SERVICE INSTRUCTION M20-108

SUBJECT: CIRCUIT BREAKER PANEL WIRING MODIFICATION AND INSPECTION OF ALTERNATOR WIRING

MODELS/ S/N M20J, 24-3000 THRU 24-3431; M20R, 29-0001 THRU 29-0288;
AFFECTED: M20S, 30-0001 THRU 30-0064

FIGURE 1

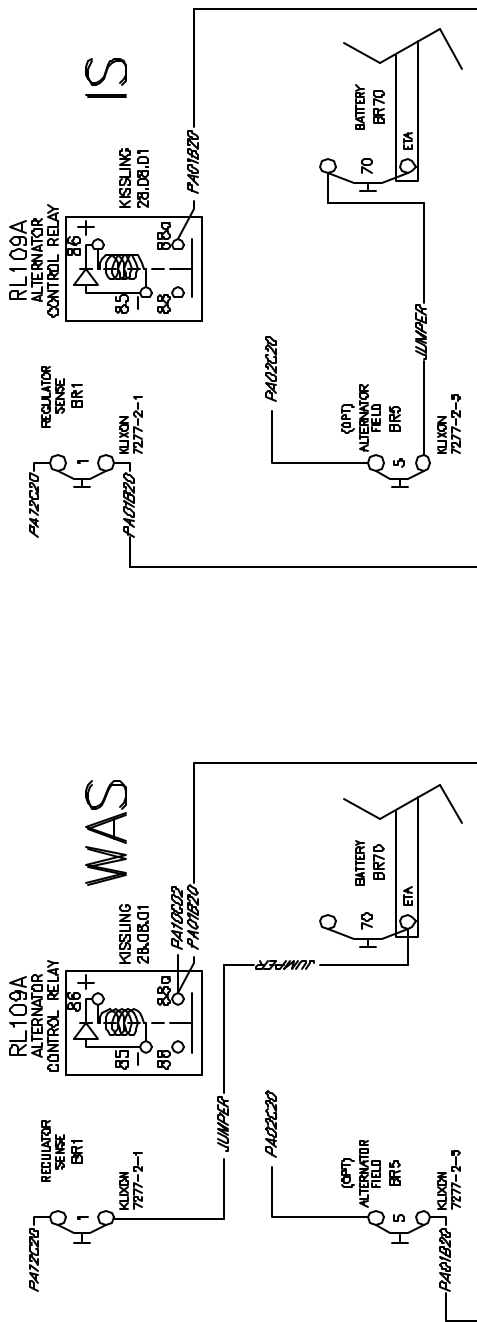
1. REF. APPROPRIATE MODEL'S SCHEMATIC [800383, REGION D-5]: CHANGE WIRING IN CIRCUIT BREAKER PANEL AS SHOWN IN FIGURE 1 BELOW.

FIGURE 2

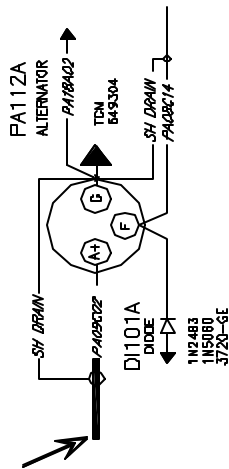
2. AT ALTERNATOR [SCHEMATIC 800383, REGION D-8] INSPECT WIRE PA09(X)02, SHIELD DRAIN TO ALTERNATOR CASE, FOR FRAYING/DAMAGE. REPAIR AS NECESSARY. COVER SHIELD DRAIN PIGTAIL WITH ANTI-CHAFING PROTECTION SUITABLE FOR THAT ENVIRONMENT, I.E. SPIRAL WRAP OR EQUIVALENT ANTI-CHAFE WRAP.
